## Macintosh LC III: New Processor Direct Slot (2/93)

Article Created: 9 February 1993

Tech Info Library Article Number: 11331

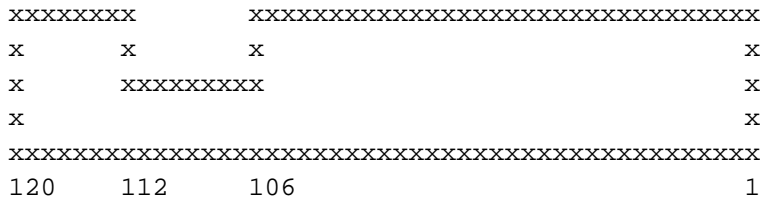
The Macintosh LC III supports a new kind of LC compatible PDS slot. It is now 114 pins, allowing support for 32-bit bus master cards while also supporting most existing 96-pin cards designed for the Macintosh LC and LC II.

This is achieved by a gap in the connector allowing a 96-pin card to fit. The connector is actually a 120-pin connector with pins 96 through 114 cut out. In profile, it looks something like this:

Some cards designed for the Macintosh LC and Macintosh LC II do not work in the Macintosh LC III because of space constraints or because they expect to be 16-bit bus masters.

Check with the manufacturer of a given card to make sure it's compatible with the Macintosh LC III.
